2015 Water Modification Forms
Unit 4 – Lewis River

| Region Reference Number- DNR Use Only | | | |
|---------------------------------------|------|------|--------|
| PC | 27 | 15 | 0108 |

Water Type Modification Form
(For changes to the Water Type Map)

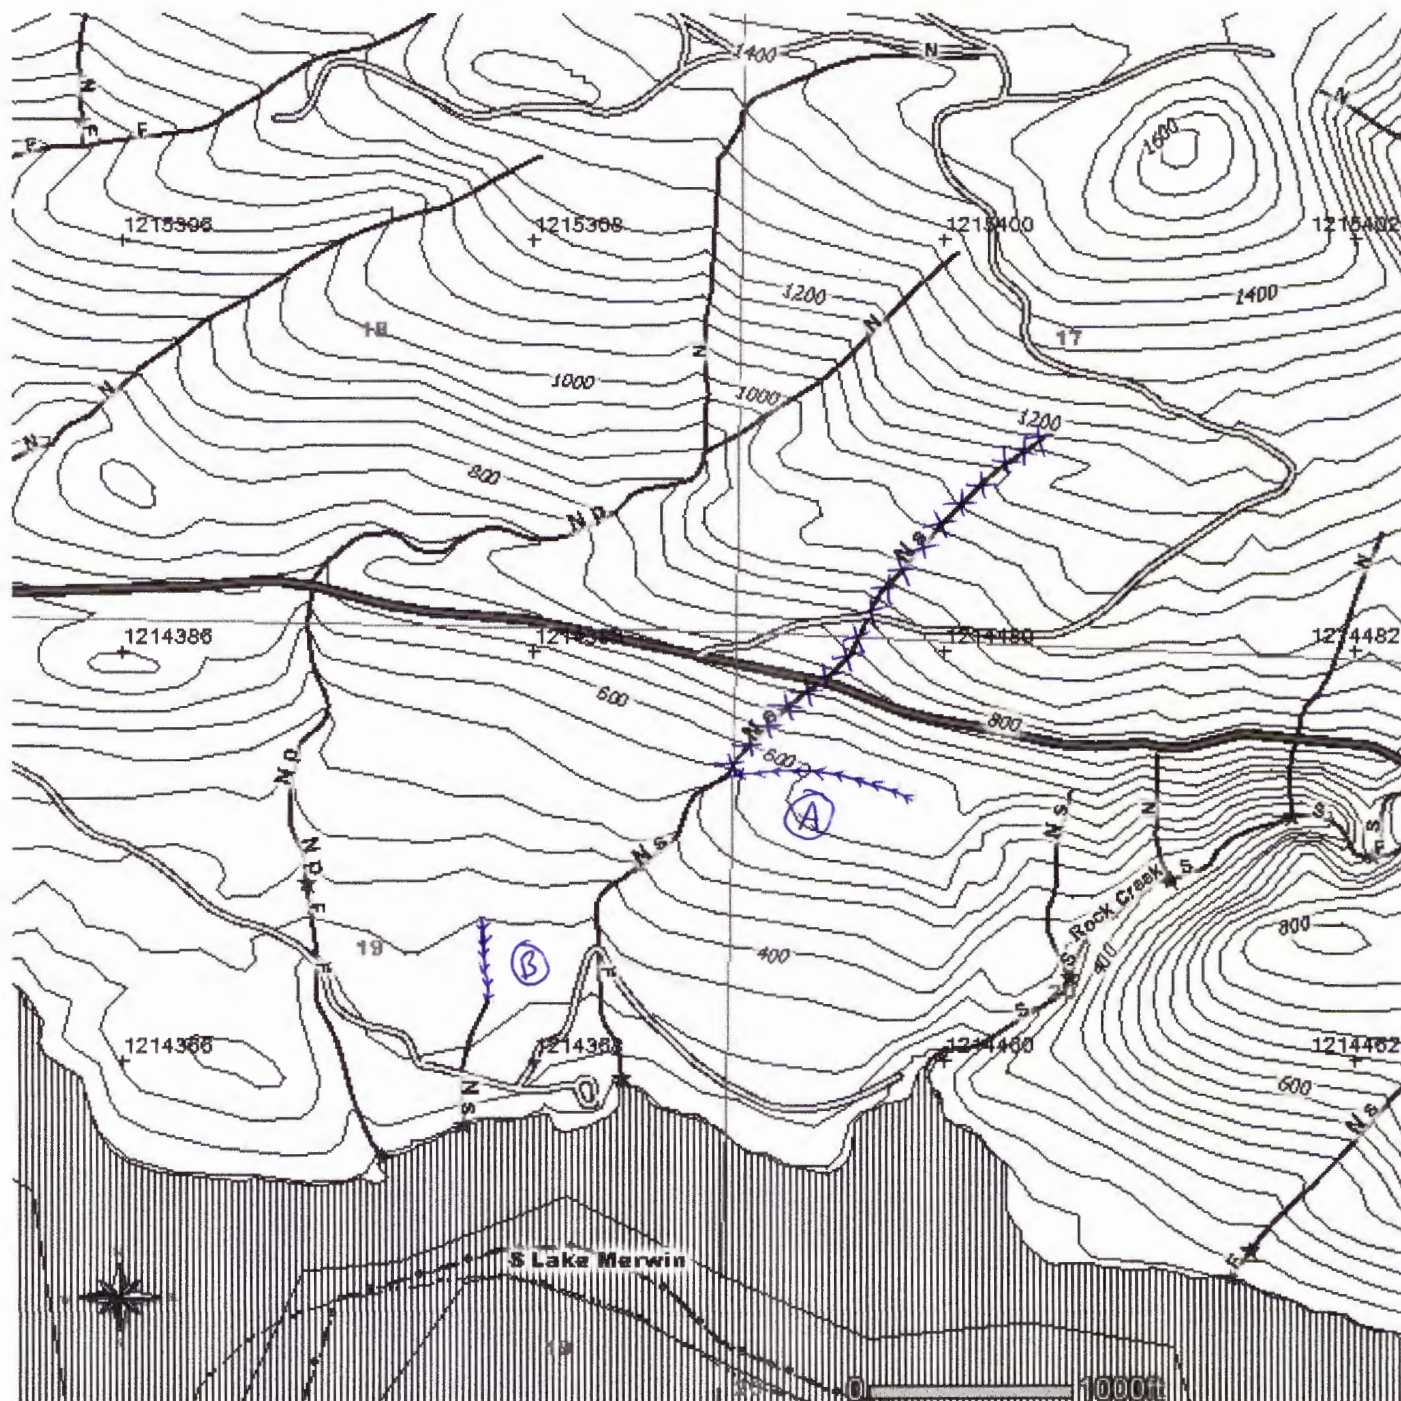
Type break based on dxr channel.

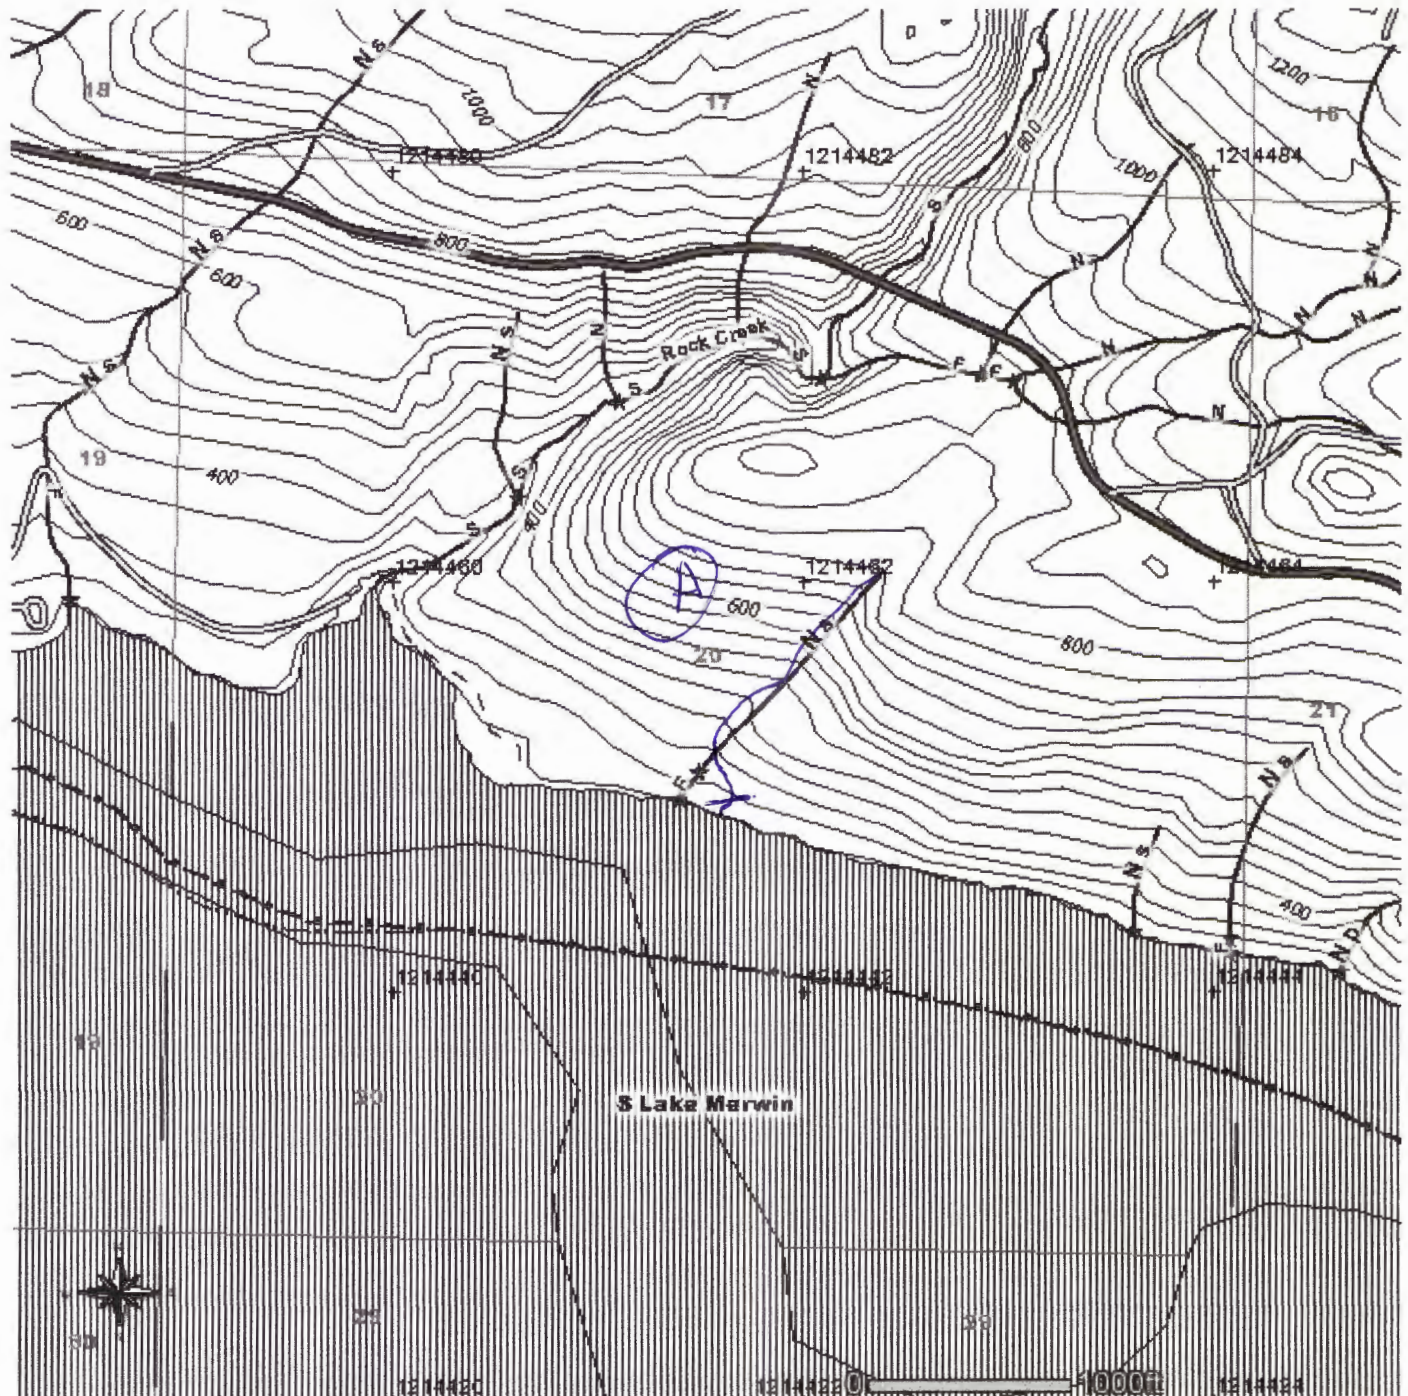
GPSd to correct location.

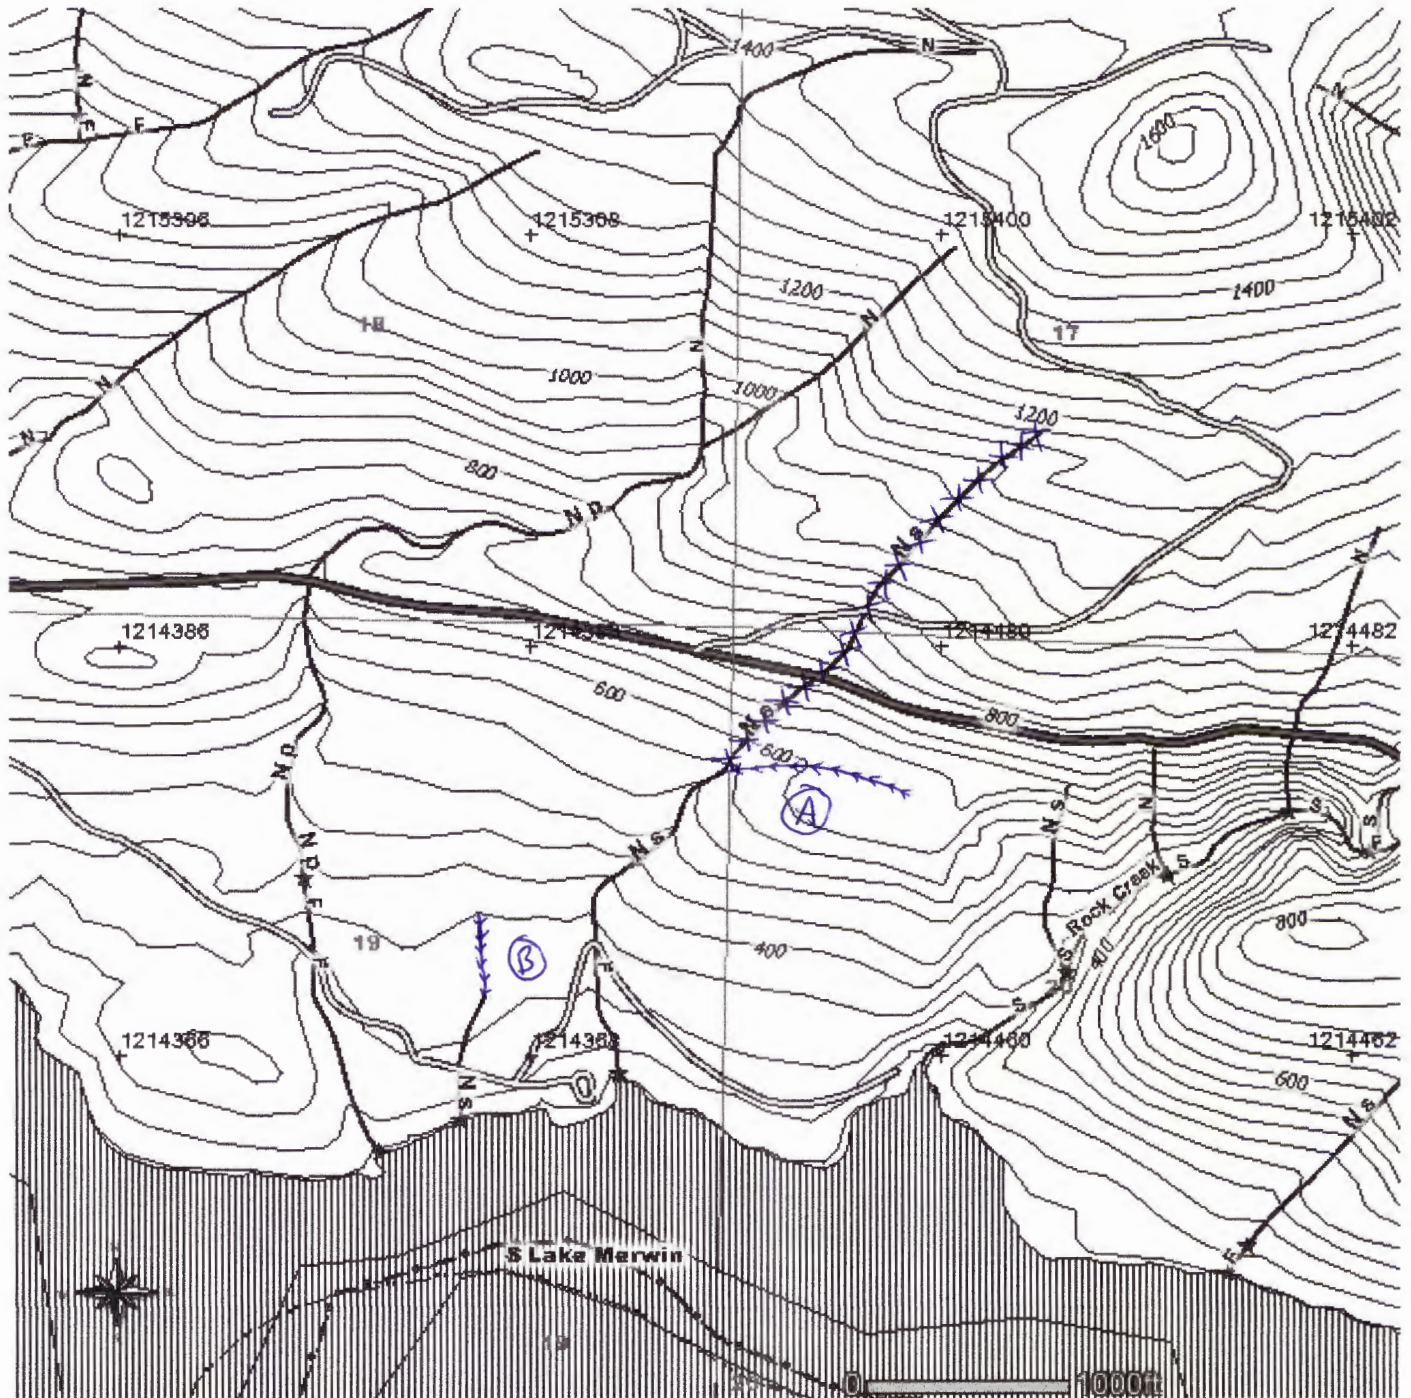
Type break based on dxr channel.

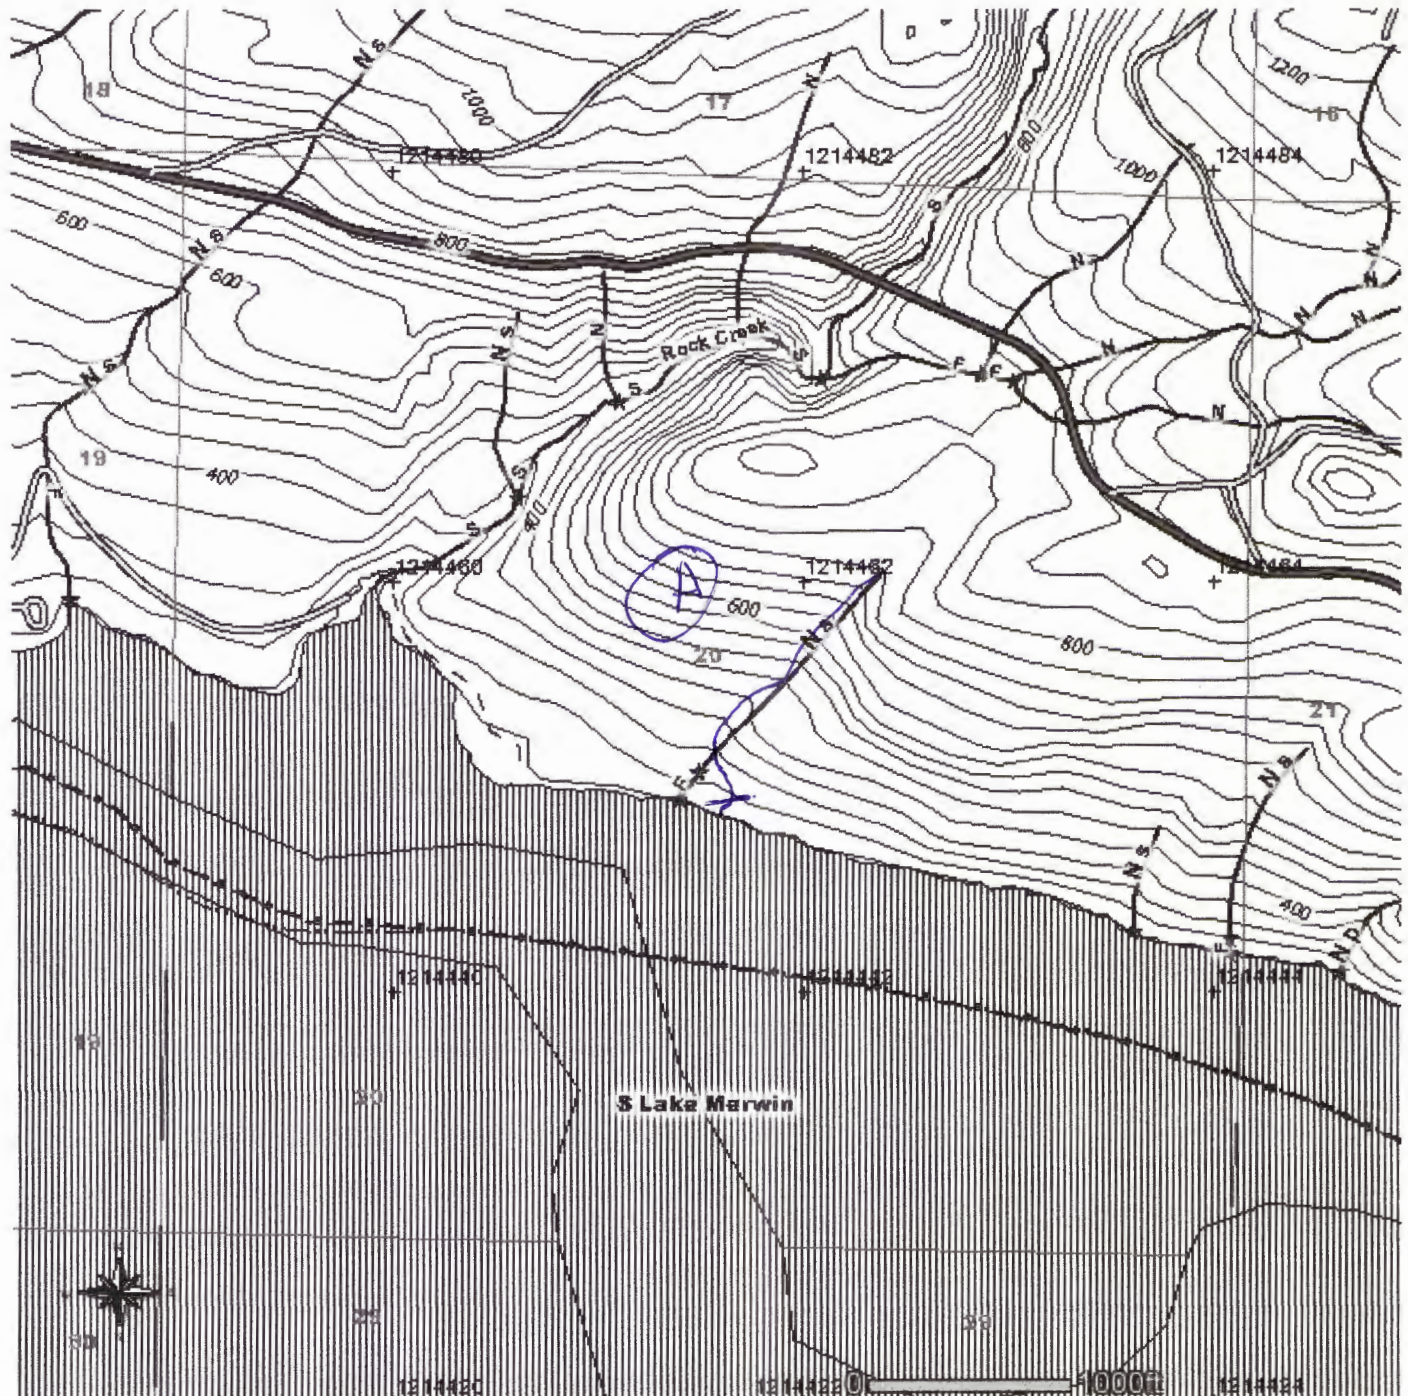
GPSd to correct location.

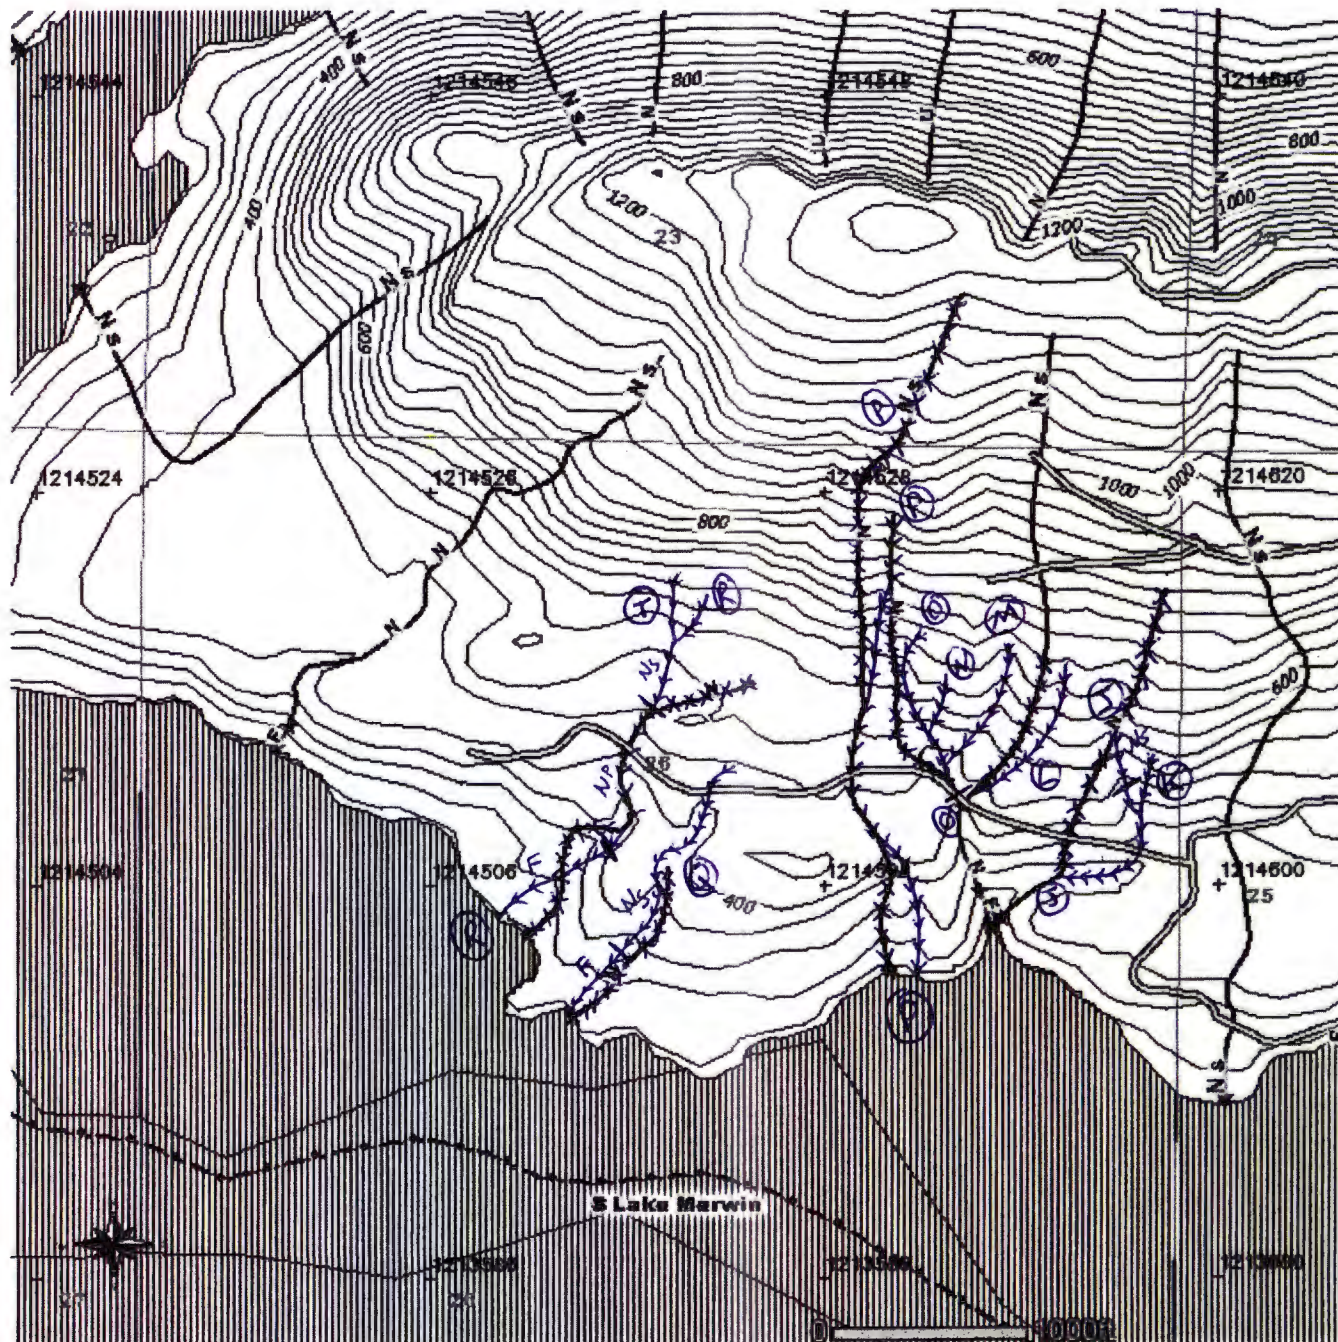
Corrected location. Stream is dry as of 04/15/15 for last 300-400' stretch.
